FCC CLASS II PERMISSIVE CHANGE REQUEST LETTER

RE: FCC Permissive II Change Request for Company: DONGGUAN TAIDE INDUSTRIAL CO., LTD. FCC ID: OYCBT008

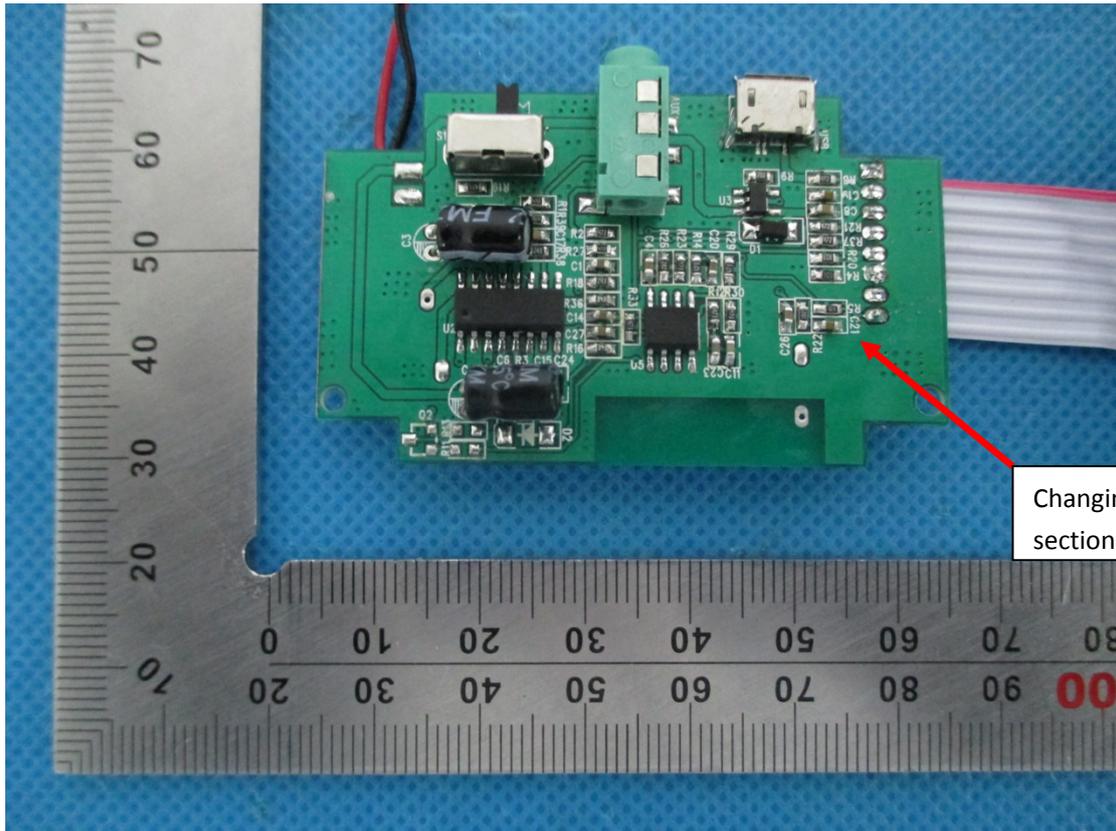
- Only the BT Module remains the same, host include quantity of resistor and capacitor changed. 9 resistors and 5 capacitors less, 6 resistors and 2 capacitors more than original product.
- The location of resistor and capacity changed
- Appearance of USB socket changed.
